25 January 1962

MEMORANDUM FOR: Chief, TID

FROM: Chief, TID/TAB

SUBJECT: Progress Report on the [REDACTED] ~~STATINTL~~ Angle Camera Calibrator Contract

Approved For Release 2001/04/02 : CIA-RDP78B04747A000600050009-2
Figure 2. (Revised 14 December 1961). TARGET ARRAY (1/2 SCALE)

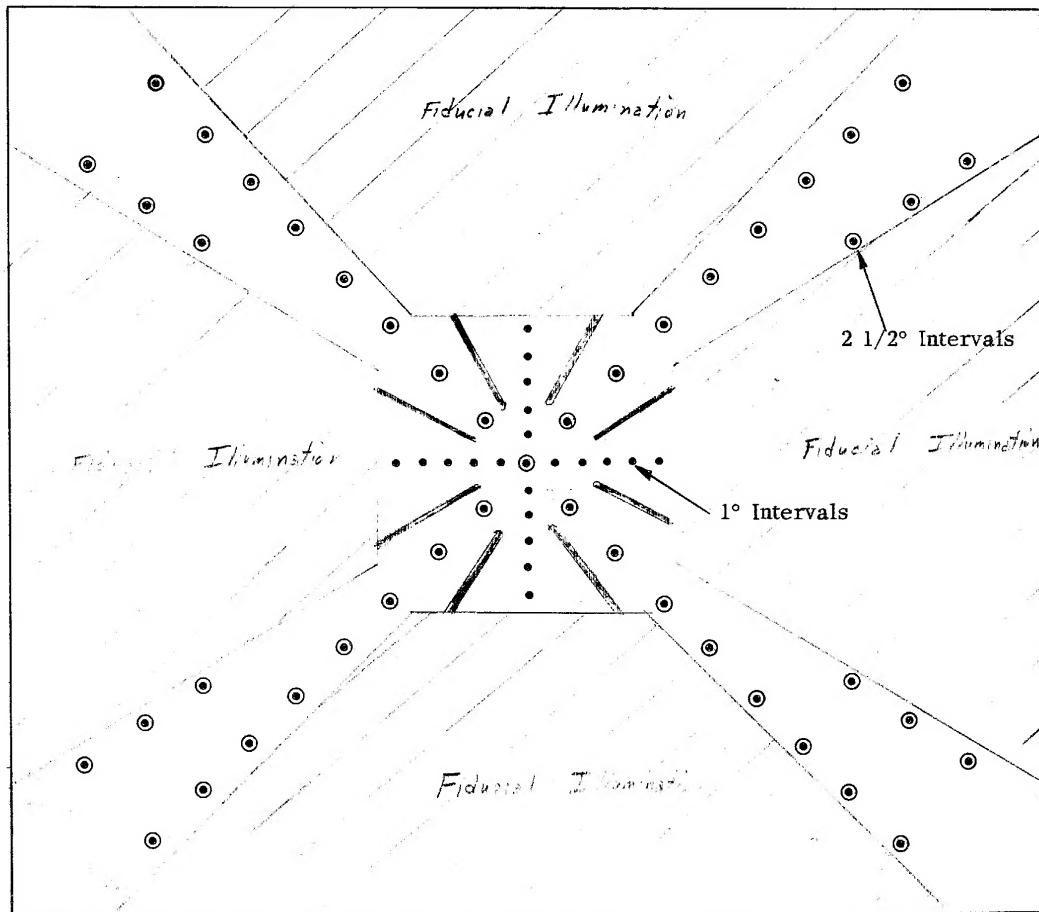
- c. Item (n) of contract: Place 12 additional targets at half-angles of 15°, 17 $\frac{1}{2}$ °, and 20° on diagonals that are at 90° to each other to accommodate cameras with a square format as well as a rectangular format.

<u>Item</u>	<u>Change</u>
(b)	Delete "24 x 36 mm" and insert "square".
(s)	Delete "45" and insert "49"
(n)	Delete sentence and insert "Place 12 additional targets at half-angles of 15°, 17½° and 20° on diagonals of a rectangular format to accommodate cameras with 24 x 36 mm format."

- a. Item (n): The placement of additional targets in the instrument so that we may calibrate most rectangular formats out to the format edge. Conventional placement of targets at right angles is not satisfactory to cover the entire rectangular format, while placement of targets at other than right angles restricts the use of square formats. Attached is a copy of the target format that will be supplied under the amendment.
- b. Item (r): To provide a electric impulse counter in both the target focal plane and on the control panel. This is

- c. Item (s): To consecutively number all targets. This is of particular importance from the view of data reduction so that the comparator operator can properly identify the particular target he is measuring.
- d. Item (t): To install fiducial or format edge illumination. The original proposal made no provision for format edge illumination to provide for location of the targets within the format. Although format edge lighting could be accomplished by a double exposure fogging technique, this has proven unsatisfactory on the present calibrator. This feature is of prime importance and alone justifies the increase in cost. The fiducial illumination will probably be provided by lighting the area around the targets as illustrated on the attached target format.
